<b>Reigate &amp; Banstead</b> BOROUGH COUNCIL Banstead   Horley   Redhill   Reigate	<b>TO:</b>	PLANNING COMMITTEE
	<b>DATE:</b>	15 May 2019
	<b>REPORT OF:</b>	HEAD OF PLACES & PLANNING
	<b>AUTHOR:</b>	Clare Chappell
	<b>TELEPHONE:</b>	01737 276004
	<b>EMAIL:</b>	Clare.Chappell@reigate-banstead.gov.uk
<b>AGENDA ITEM:</b>	11	<b>WARD:</b> Reigate

<b>APPLICATION NUMBER:</b>	18/02453/F	<b>VALID:</b>	<b>03/01/2019</b>
<b>APPLICANT:</b>	Elvington Lodge Resident Association	<b>AGENT:</b>	P M Ironwork Ltd
<b>LOCATION:</b>	<b>ELVINGTON LODGE, 40 REIGATE HILL, REIGATE</b>		
<b>DESCRIPTION:</b>	<b>Installation of frontage boundary railings and sliding entrance gate as per design drawings to a height of 1.200 Metres to match the existing railings of the neighbouring property. As amended on 11/02/2019 and on 02/04/2019.</b>		
<b>All plans in this report have been reproduced, are not to scale, and are for illustrative purposes only. The original plans should be viewed/referenced for detail.</b>

# 18/02453/F - Elvington Lodge, 40 Reigate Hill, Reigate

**Drg no 051-32 sht 2B**  
**Plan of proposed gates & railings**  
 Scale 1-100 22 Oct 2018  
 Drawn by DHB.

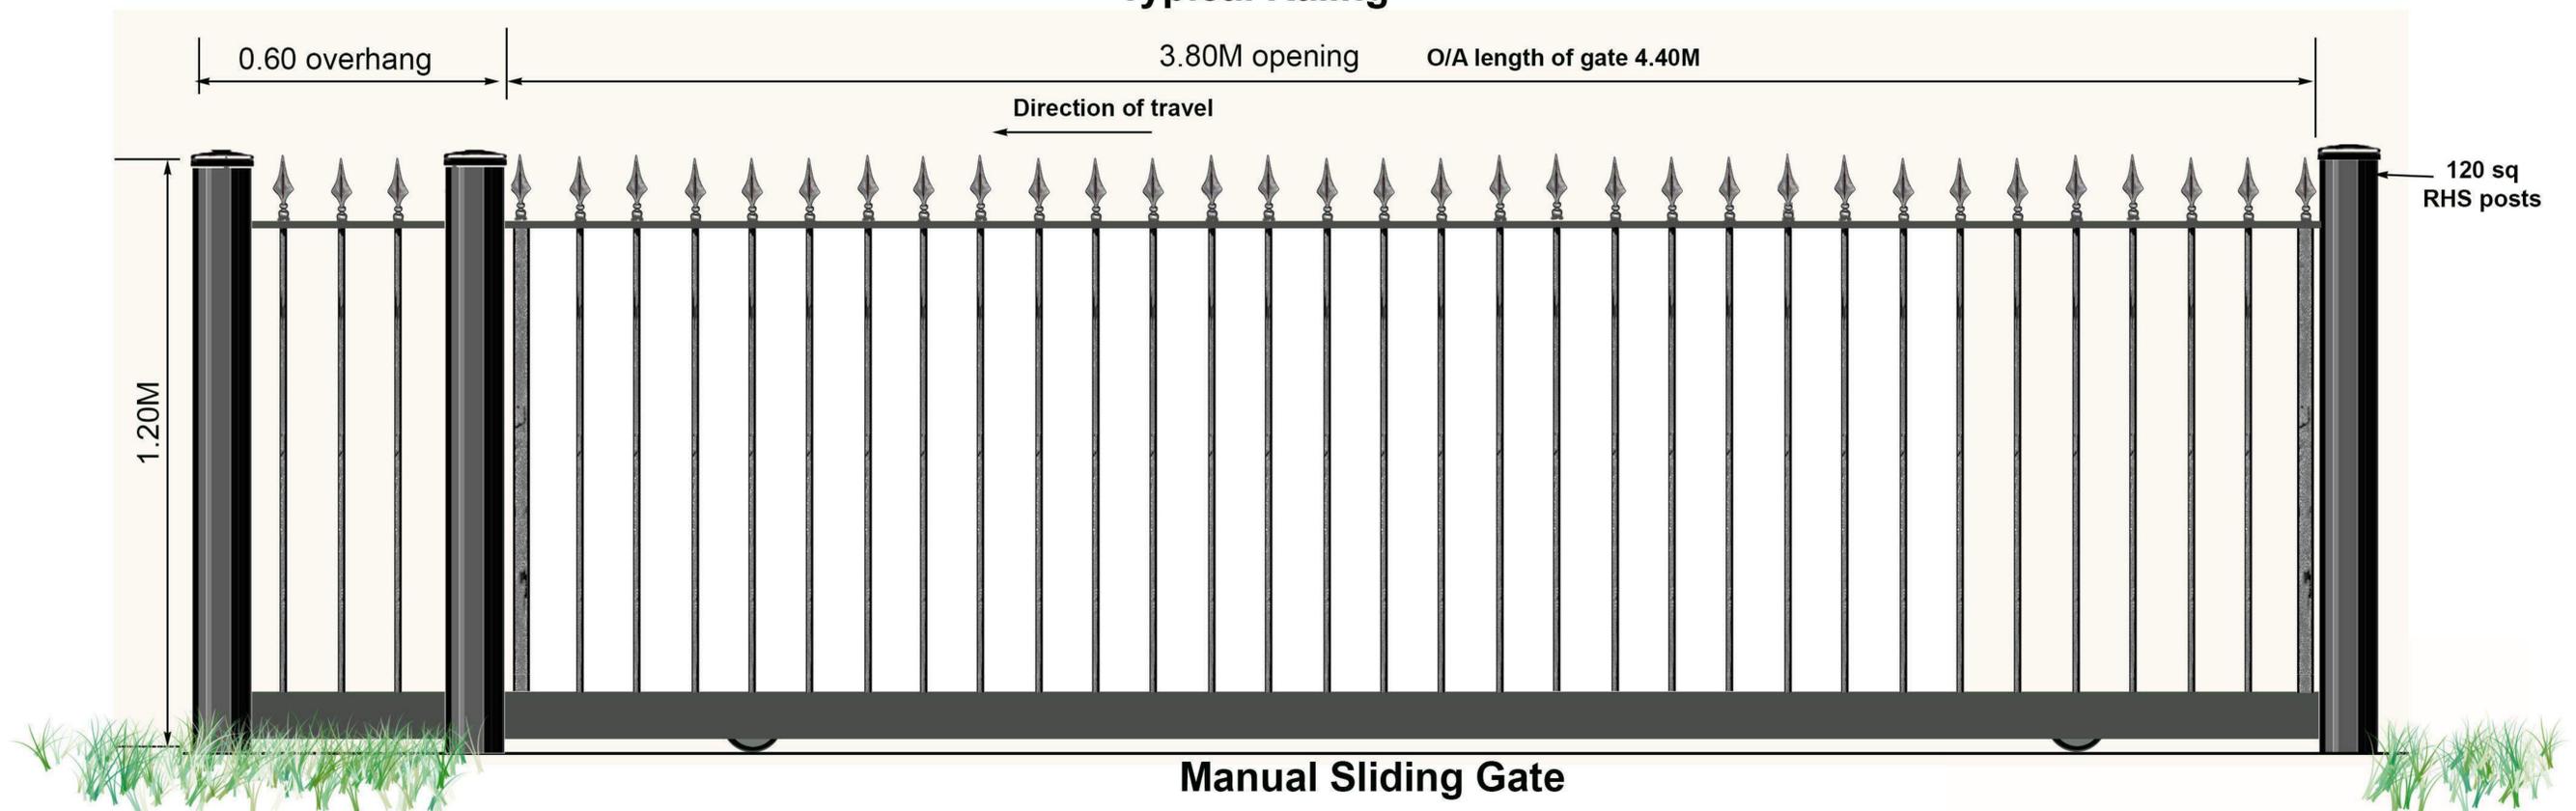
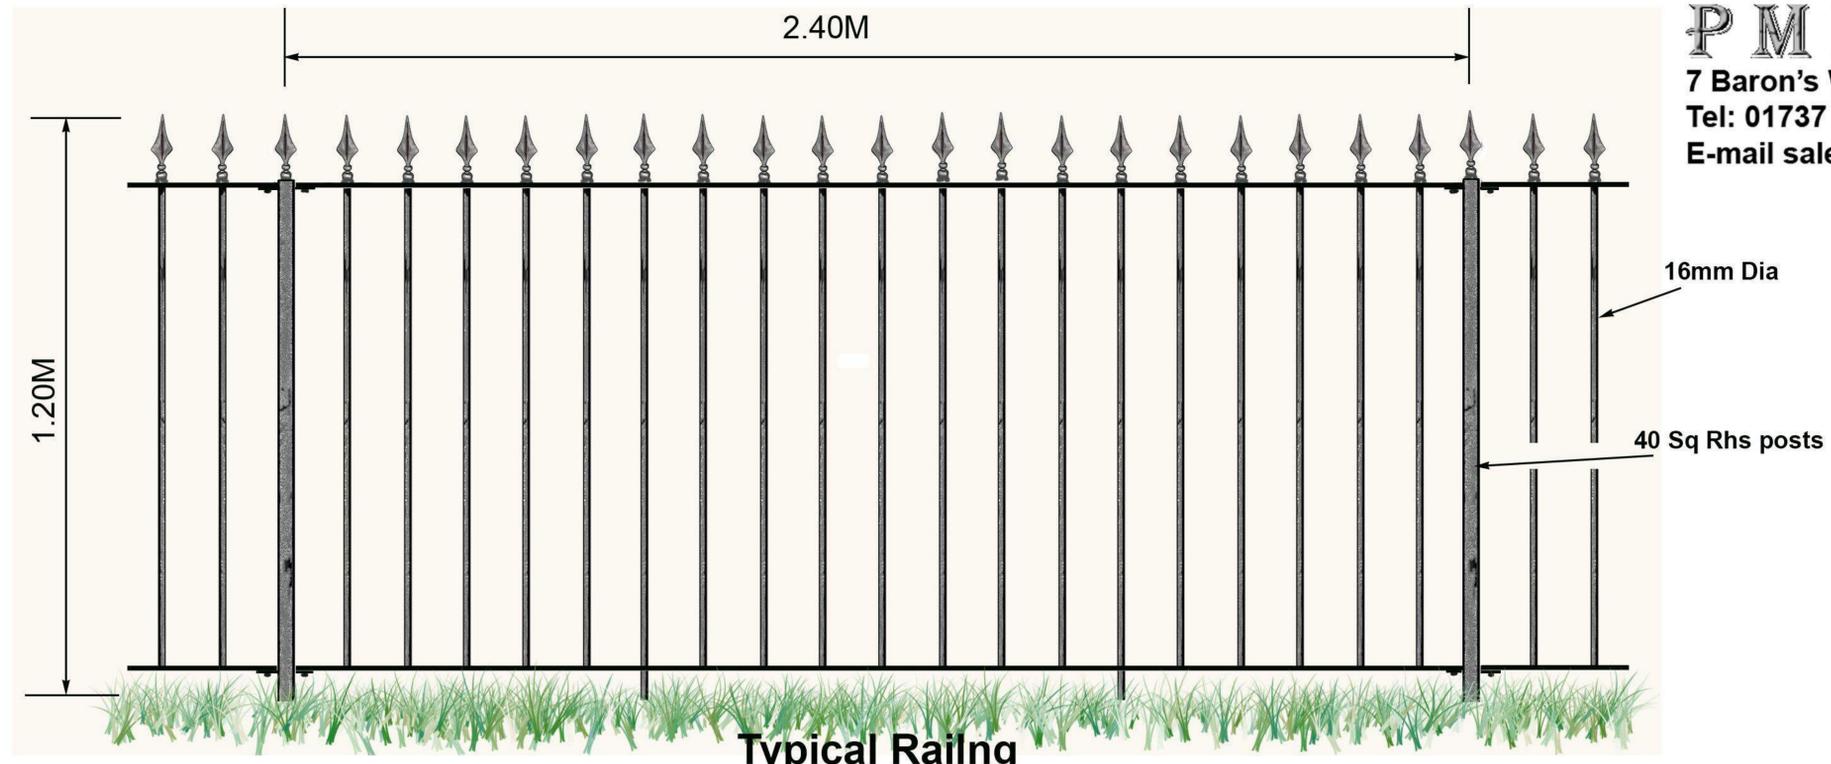
*Place). The dimensions don't seem quite, it seems 3.1metres from edge of the kerb is the width of the pavement rather than the depth back of the railings, which are indicated about a metre back from the pavement, which would on the same line as the trunk of one of the trees.*

- 6.4 It is clarified that the position of the railing would be at the back edge of the pavement which coincides with the land ownership boundary. The sliding gate would run behind the railing. In the absence of an arboricultural assessment and in the absence of dimensions on the site layout drawing, the exact distance from the railing/posts/gate to the trunks of the two trees is unknown.

- 6.9 The proposed site layout drawing has been updated during the course of the application to include signage as requested by the Highway Authority. The signage is designed to discourage vehicles from using the entry opening for both entry and exit. Please see the extract below from the Highway Authority's initial comments:

*“If a manual gate were to be installed at the southernmost site access vehicles may be encouraged to use the northernmost access for both entry and exit of the site. However, from the plans submitted it does not appear that this access is wide*

*enough to facilitate simultaneous entry and exit, as would be necessary for an access serving this number of dwellings on an 'A' class road."*

- 6.10 To address this issue, the site layout drawing shows the appropriately located 'entry', 'no exit', 'exit' and 'no entry' signs. The final comments from the Highway Authority are as follows:

*1) The railings hereby approved shall not be installed unless and until the 'entry/ no exit' and 'exit/ no entry' signs have been installed at the site in accordance with the approved plans. Thereafter the signs shall be permanently retained and maintained.*
